TECHNICAL BULLETIN

MAINTENANCE KIT, ELECTRICAL (NSN 5935-01-524-9798) FOR AM-7239E/VRC (NSN 5895-01-444-1218):

GPS CONNECTOR REMOVAL TO ALLOW INSTALLATION OF SINCGARS RT-1523A (NSN 5820-01-318-7990)

No. 11-5820-890-30-6

Figure 1. RF Cable Assembly (5A1W8)

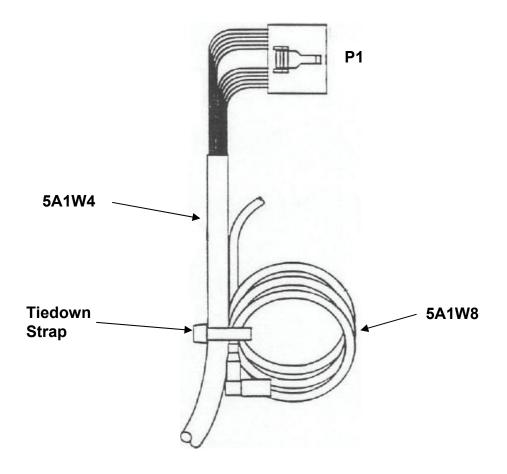
c. RF Cable (5A1W8)	Shrink-wrap end of RF Cable Assembly (5A1W8) to prevent from possible electrical shorting of electrical components.
d. RF Cable (5A1W8)	Obtain tie-strap from kit. Coil RF Cable Assembly (5A1W8) and fasten using tie- strap to Cable Assembly (5A1W4) (See Figure 1).
